TOWN OF POUGHKEEPSIE
ARLINGTON WASTEWATER TREATMENT PLANT
PIPE COUPLINGS REPLACEMENTS
POUGHKEEPSIE, NEW YORK

CONTRACT 2013-01

Addendum No. 1
August 28, 2013

VANE-FLO PUMP RANGE CHART

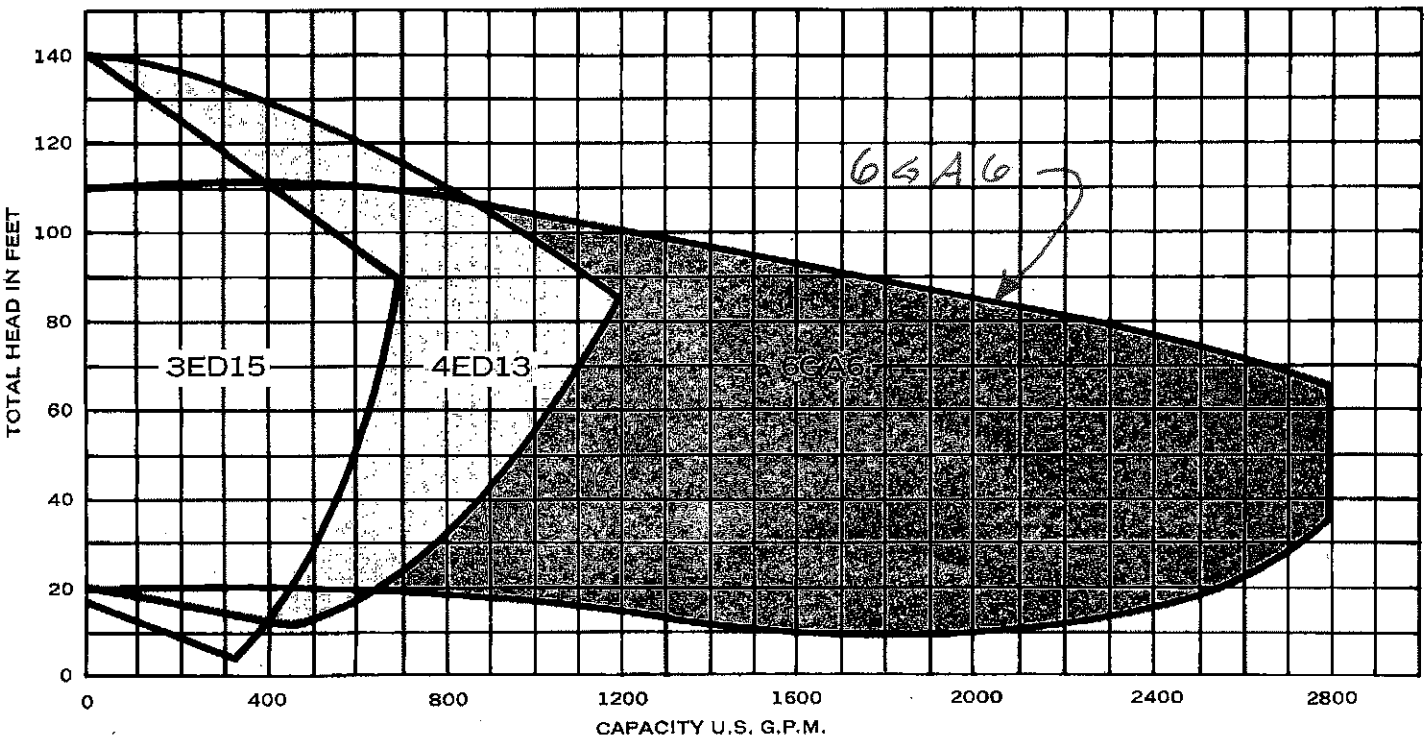
Q What is the pressure on the discharge side of the RAS pump?
A The plant operator is not able to install a pressure gauge. Attached is a copy of the manufacturer's cut sheet showing the pump range chart. The pumps at the plant are models 6GA6 SL. The 6GA6 series, per the cut sheet (page 3 of this addendum), have a range of 15 to 100 feet of head at 1200 gpm.
